May 5, 2000

LICENSEE: STP Nuclear Operating Company

FACILITY: South Texas Project, Units 1 and 2

SUBJECT: SUMMARY OF MEETING WITH STP NUCLEAR OPERATING COMPANY TO DISCUSS SOUTH TEXAS PROJECT, UNITS 1 AND 2, RISK CATEGORIZATION PROCESS FOR THE MULTIPART EXEMPTION FROM THE SPECIAL TREATMENT RULES OF 10 CFR PART 50

**Figure 1: Diagram of Categorization and Treatment**

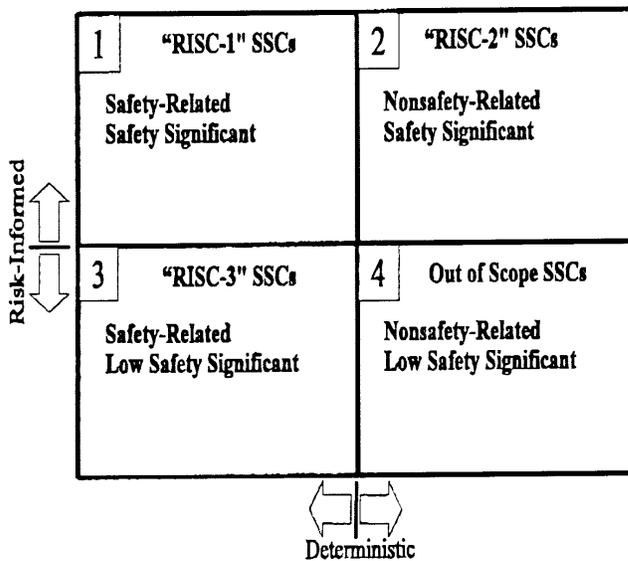
1. In SECY-99-256, "Rulemaking Plan for Risk-Informing Special Treatment Requirements," the NRC staff describes a scheme for categorizing SSCs according to their safety significance and status under the deterministic safety-related regime. This scheme divides SSCs into 4 bins. (See Figure 1.) Risk-informed safety class 1, or RISC-1 SSCs are presently safety-related and are determined to be safety significant by a risk-informed categorization process. RISC-2 SSCs are not presently safety-related, but have been determined to be safety significant by a risk-informed categorization process. RISC-3 SSCs are presently safety-related, but have been found to be of low safety significance by a risk-informed categorization process. Remaining SSCs are expected to be out of the scope of special treatment requirements, though other regulatory controls may still apply.

In an effort to equate current Risk-informed Rulemaking efforts with your exemption request, please describe how the STP risk categorizations compare to these classifications.

Figure 3: Comparison of STP Programmatic Controls to NRC Proposed Categorization and Treatment

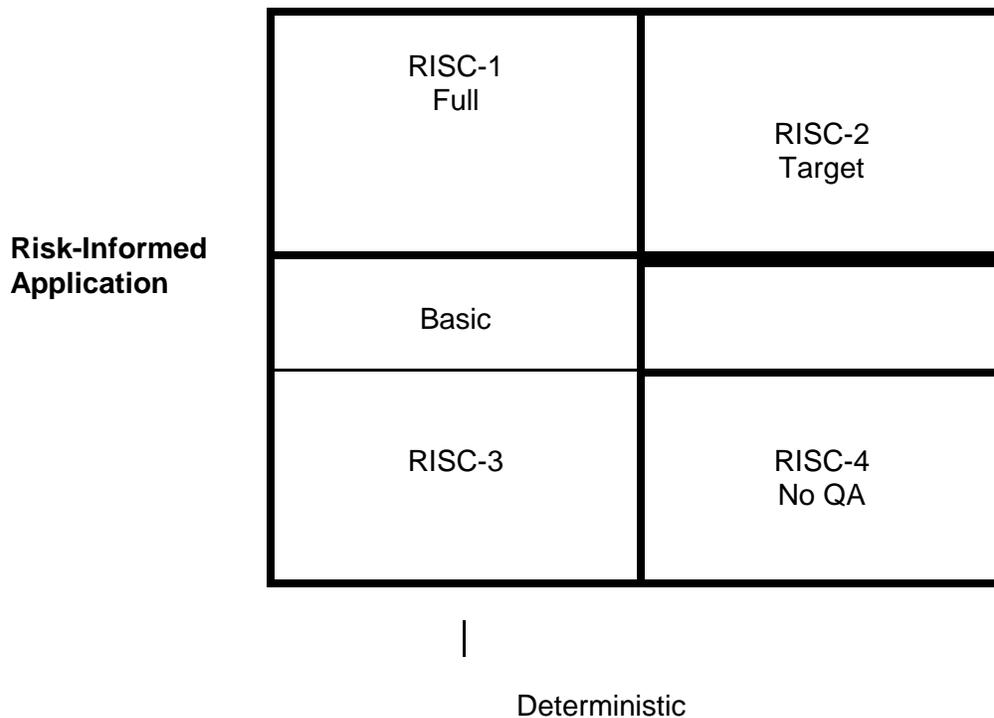
- Q47 - [RAI Enclosure 2] The licensee noted that the scope of exemption is equivalent to RISC-3 discussed in SECY 99-256 ("Rulemaking Plan for Risk-Informing Special Treatment Requirements")(safety-related, low safety significant).

the component being categorized as HIGH or MEDIUM. Components under these controls will remain non-safety-related and will be procured commercial, but the special treatments will be appropriately applied to give additional assurance that the component will be able to perform its function when demanded. TARGET controls directly equate to the RISC-2 proposed box of 'non-safety-related, safety significant'.

NO regulatory controls have been applied to these non-safety-related, LOW and NRS categorized components, and upon grant of the Exemption, no regulatory controls would be added. Components in this category would still receive appropriate administrative controls to give reasonable assurance that these components will perform efficiently and reliably. The components whose additional controls are NONE equate directly to the proposed RISC-4 box, 'non-safety-related, low safety significant'.
